VOLUME 18

CNP UNITS 1 AND 2 IMPROVED TECHNICAL SPECIFICATIONS CONVERSION

UNIT 2 CTS MARKUP PAGES IN CTS ORDER

Revision 0

FIGURE 3.1-2

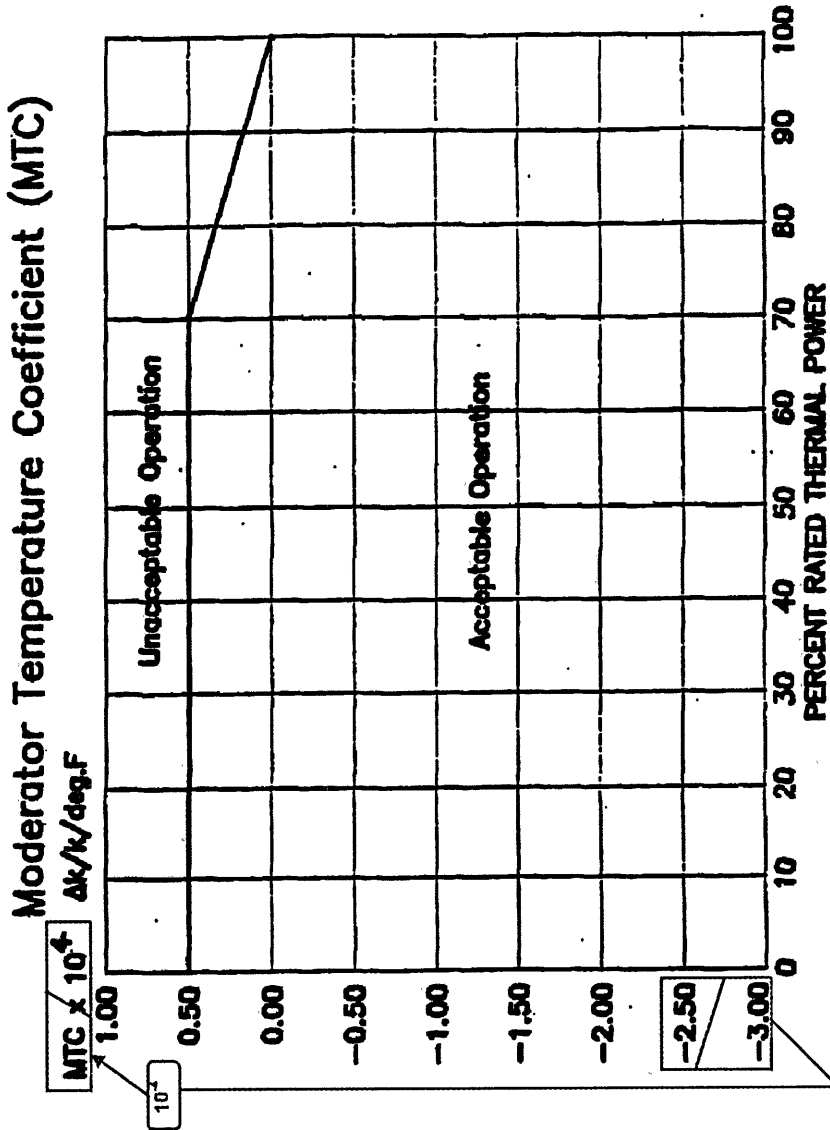
Figure 3.1.3-1

A.6

FIGURE 3.1-4

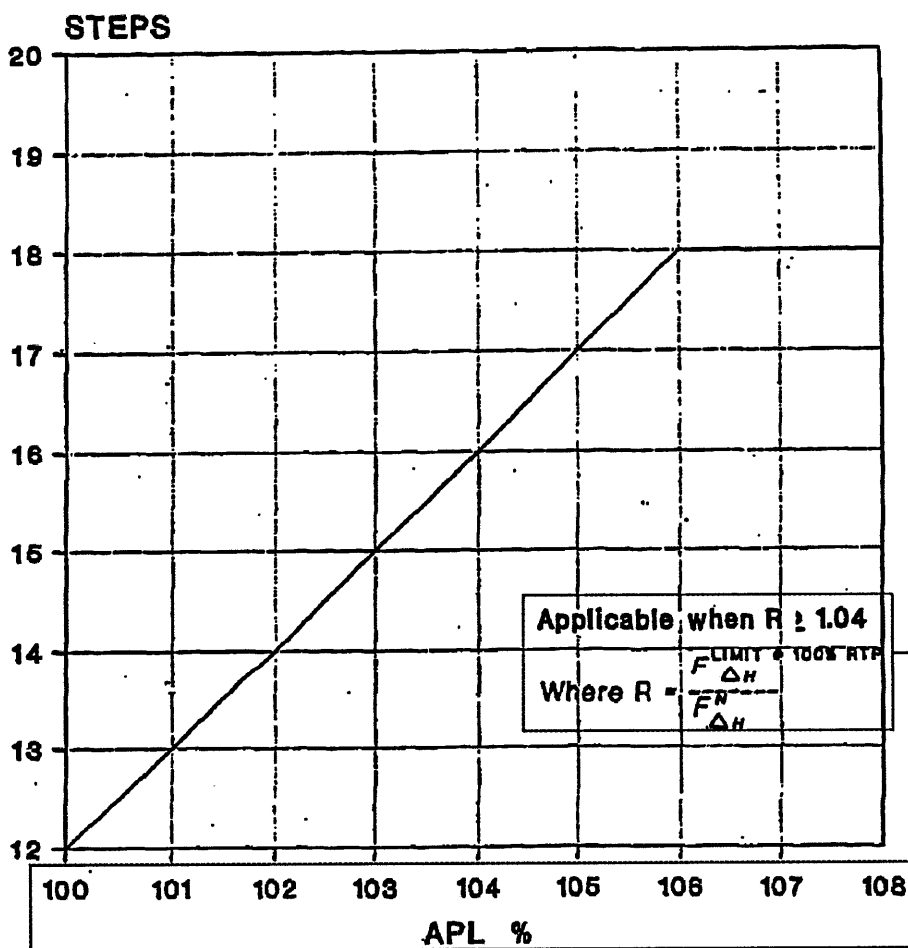
Figure 3.1.4-1

LCO 3.1.4
Note

FIGURE 3.4-1

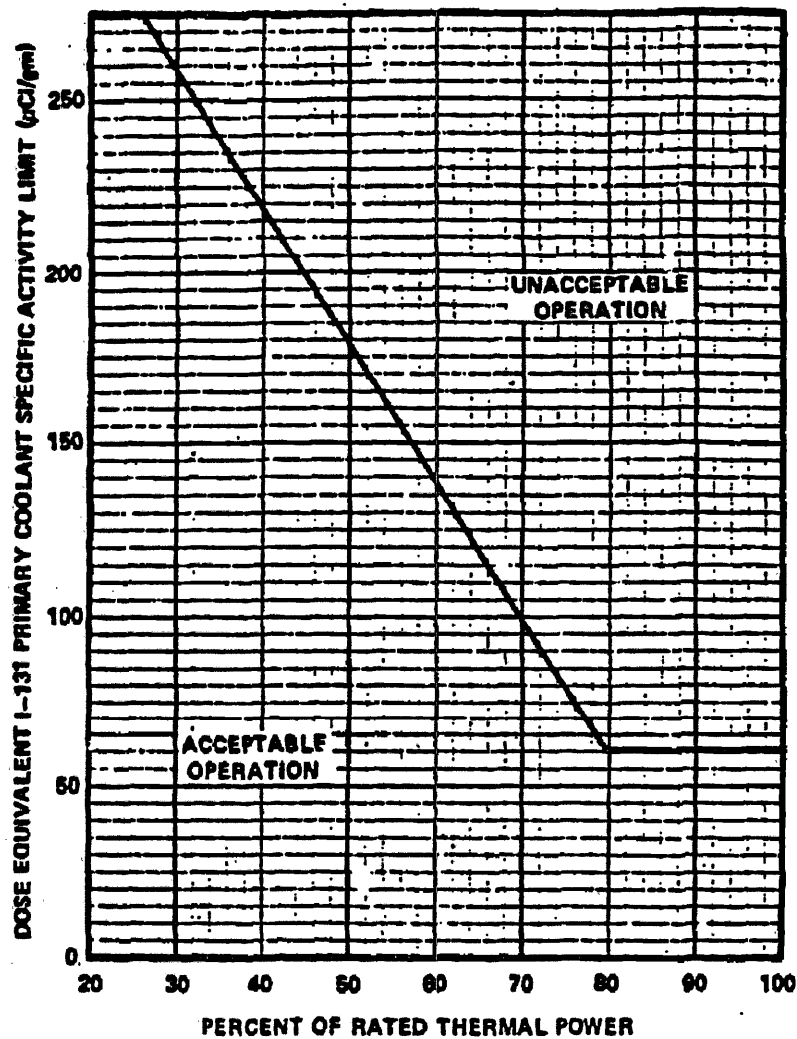
Figure 3.4.16-1

FIGURE 3.4-2
REACTOR COOLANT SYSTEM PRESSURE - TEMPERATURE LIMITS FOR
60°F/HR RATE, CRITICALITY LIMIT, BOLTUP LIMIT, AND LEAK TEST LIMIT

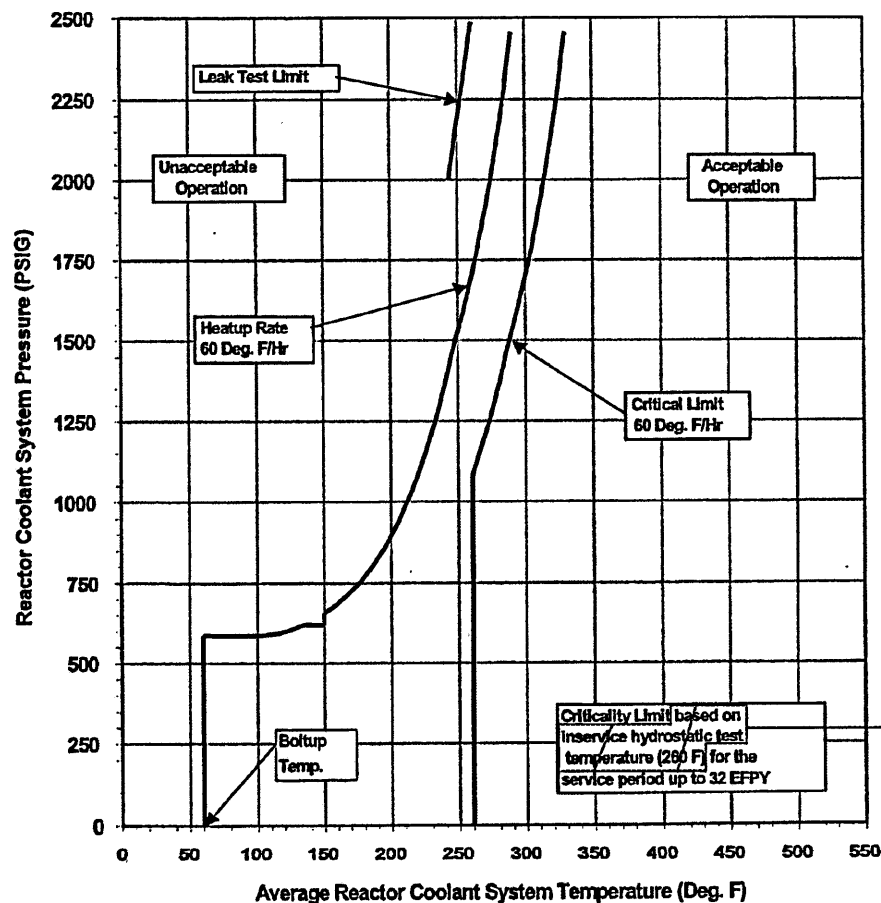
Figure 3.4.3-1

L.2

Figure 5.6-2: Interim Storage Pattern (Checkerboard)

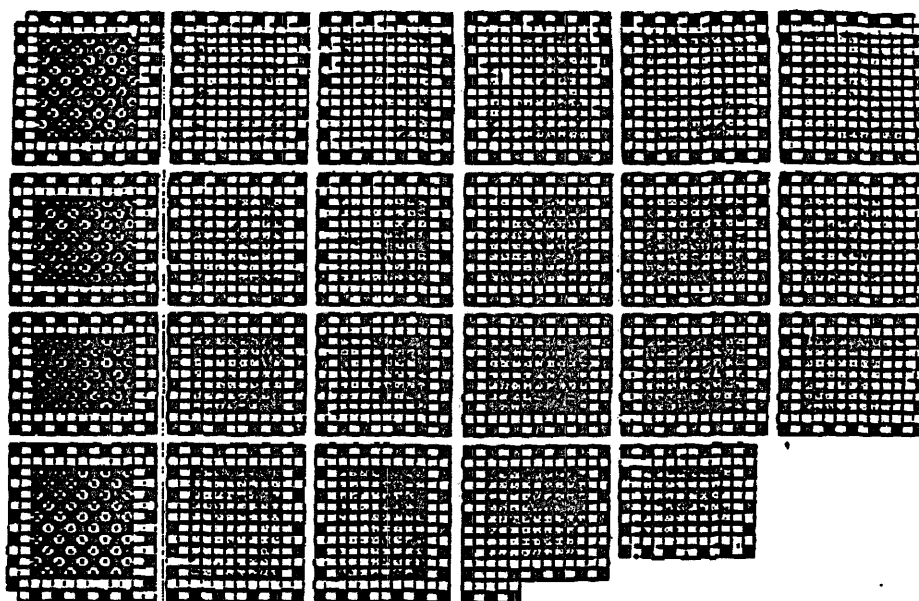
Figure 4.3-2

A.3

Figure 5.6-4: New Fuel Storage Rack Integral Fuel Burnable Absorber (IFBA) Requirements

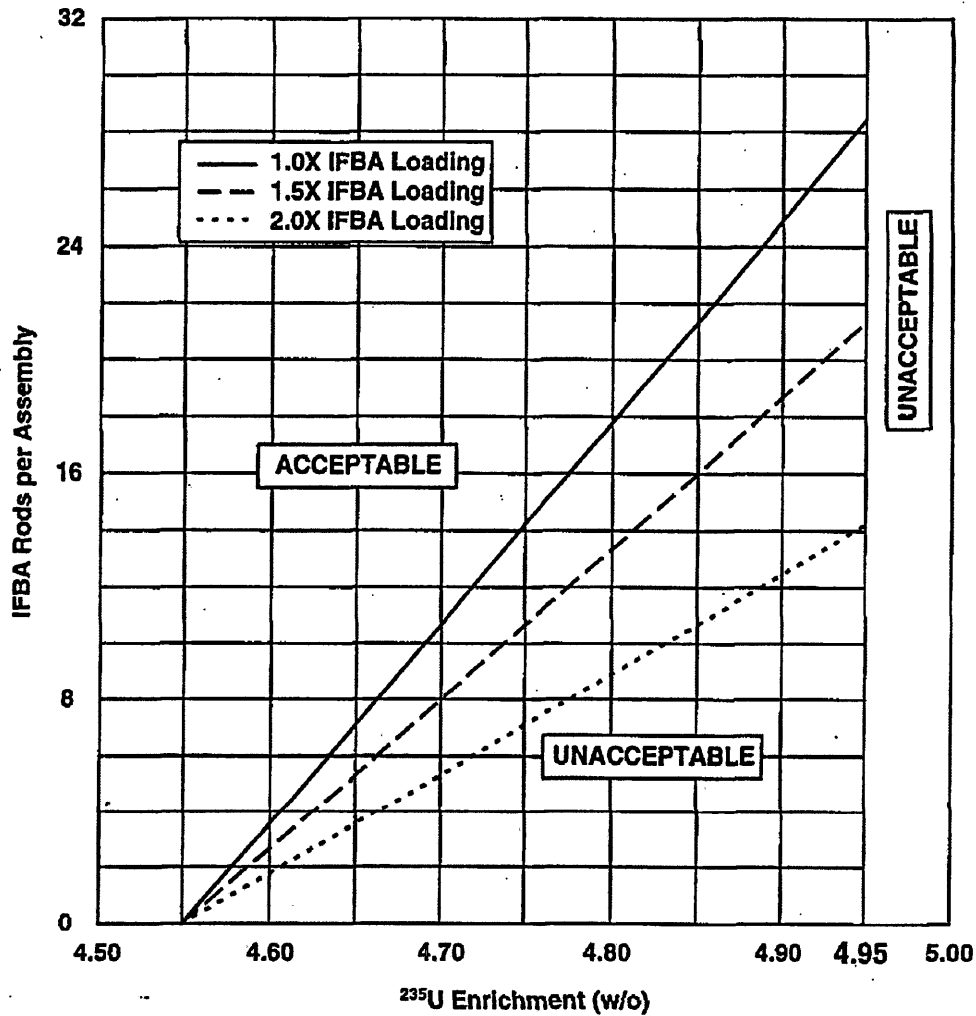
Figure 4.3-3

FIGURE 5.1-3: SITE BOUNDARY FOR LIQUID AND GASEOUS EFFLUENTS

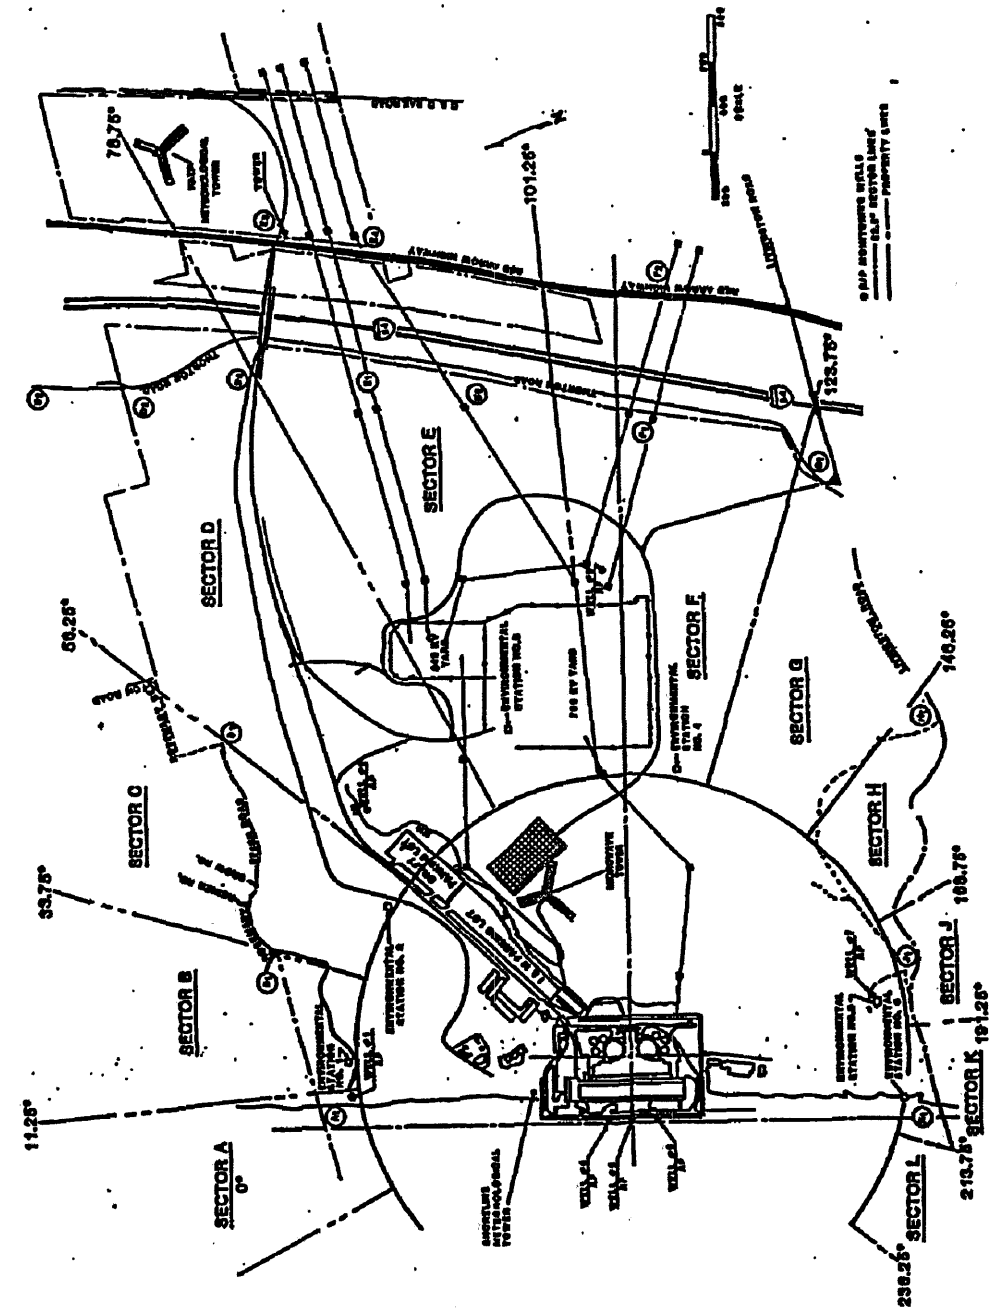
Figure 4.1-1
